The following is an edited version of section 5 from SAS-r00e. Changes included reflect the input to this section agreed upon by the SAS PHY Working group and are found in the following T10 documents: 02-183r0, 02-210r2, 02-229r0, 02-243r0, 02-265r0, 02-288r0

## 5 Physical layer

**Figure 27. Deriving a tolerance mask at Dt, Ct, It, or Xt**

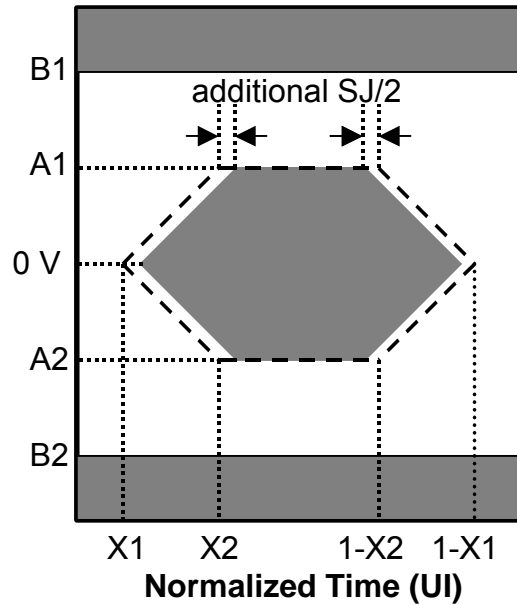
Tolerance eye masks at Dt, Ct, It, and Xt shall be based on Figure 27 and shall be constructed using the X2, Z1 and Z2 values given in **Table 17**. X1 values shall be half the value for total jitter given in the tables for jitter value frequencies above bit rate/1 667.

Note that tThe tolerance masks are identical to the output masks except that the X1 and X2 values are each increased by half the amount of the sinusoidal jitter values given in the jitter tolerance tables.

**Figure 28. Deriving a tolerance mask at Dr, Cr, Ir, or Xr**

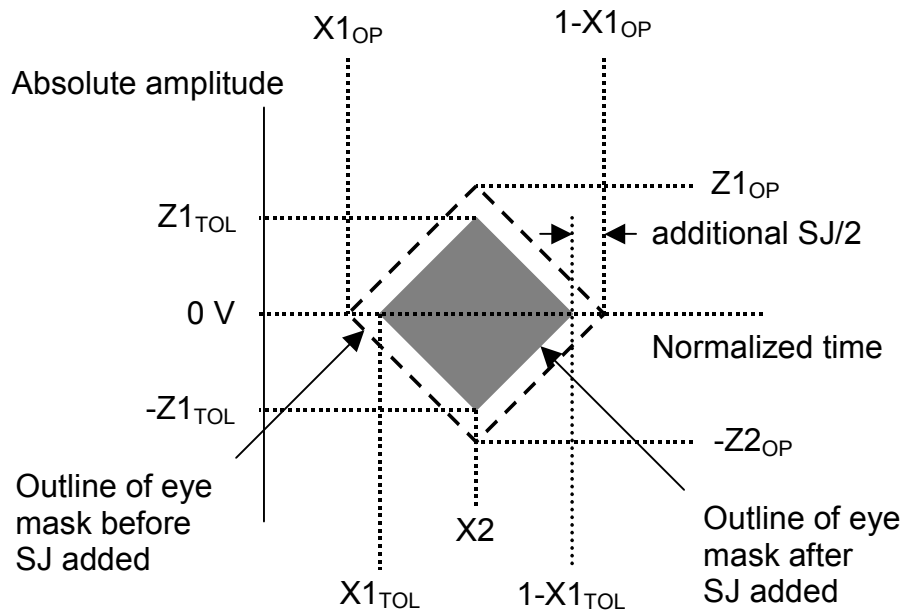
Receiver Tolerance eye masks at Dr, Cr, Ir, and Xr shall be based on Figure 28 and shall be constructed using the X2 and Z2 values given in **Table 17**. X1 shall be half the value for total jitter given in these tables for jitter frequencies above bit rate/1 667.

However, the leading and trailing edge slopes of Figure 26 shall be preserved. As a result the amplitude value of Z1 is less than that given in Table 15 and must therefore be calculated from those slopes as follows:

**Note that t**he X1 points in the receive tolerance masks are greater than the X1 points in the output masks, again due to the addition of sinusoidal jitter.
